Product/Process Change Notice

Application or type : The 0201 packaging change.

Detail of the change : The bottom PAD product design changes.

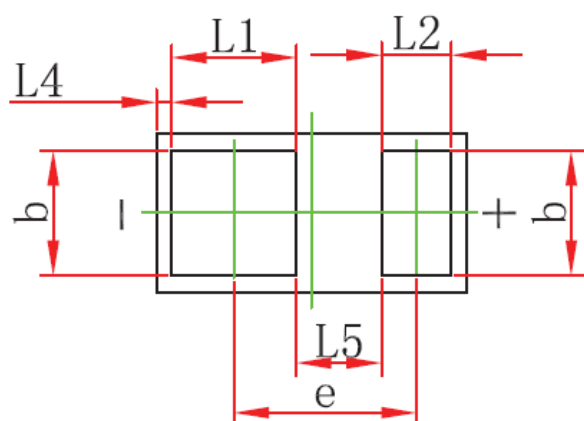
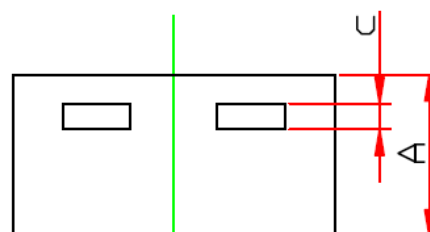
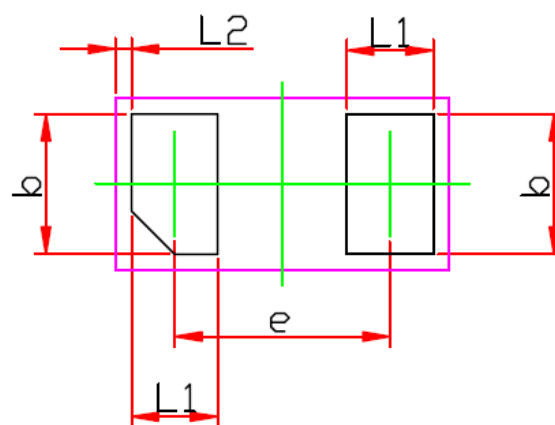
Reason for the change : 1. Change bottom PAD effectively improve process yield.												
Evaluation items : 1. Part No. affected:

DFNWB0.6×0.3-2L(P0.40T0.31)Outline Drawing

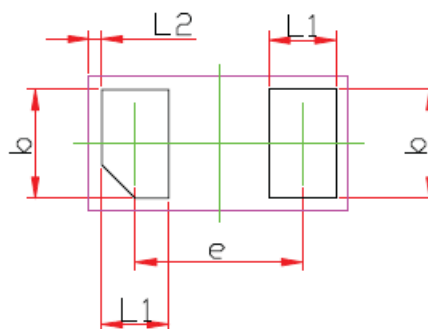
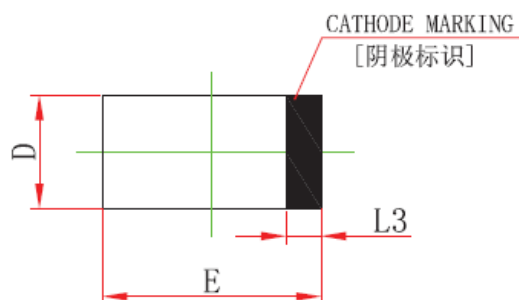
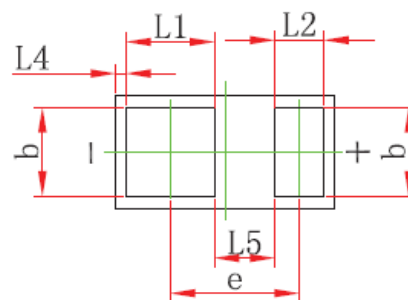
After the change

Before the change

Symbol	Dimensions In Millimeters		Dimensions In Inches	
	Min.	Max.	Min.	Max.
A	0.275	0.340	0.011	0.013
D	0.570	0.670	0.022	0.026
E	0.270	0.370	0.011	0.015
b	0.225	0.295	0.009	0.012
c	0.050 REF.		0.002 REF.	
e	0.365	0.435	0.014	0.017
L1	0.125	0.195	0.005	0.008
L2	0.030 REF.		0.001 REF.

Symbol	Dimensions In Millimeters		Dimensions In Inches	
	Min.	Max.	Min.	Max.
A	0.275	0.340	0.011	0.013
D	0.270	0.370	0.011	0.015
E	0.570	0.670	0.022	0.026
b	0.200	0.300	0.008	0.012
e	0.330	0.400	0.013	0.016
L1	0.200	0.300	0.008	0.012
L2	0.100	0.190	0.004	0.007
L3	0.100 REF.		0.004 REF.	
L4	0.030 REF.		0.001 REF.	
L5	0.150 REF.		0.006 REF.
